SI M51 09 14
Body Equipment

Recall Campaign 15V-450: Side Impact Performance

NEW F56 (MINI Cooper Hardtop 2-door)

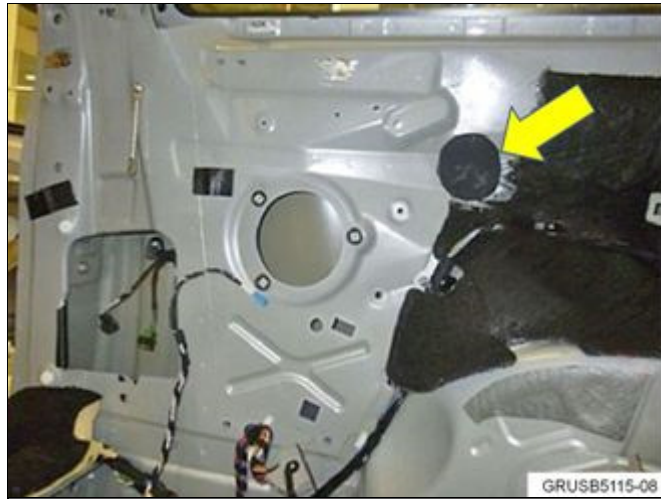
Please note that many vehicles affected by this repair (installation of a "Patch), are also affected by the replacement of a "Label" ([SI M71 01 15](#)), and the installation of an "L-Pad" ([SI M51 04 15](#)), as illustrated in the chart below.
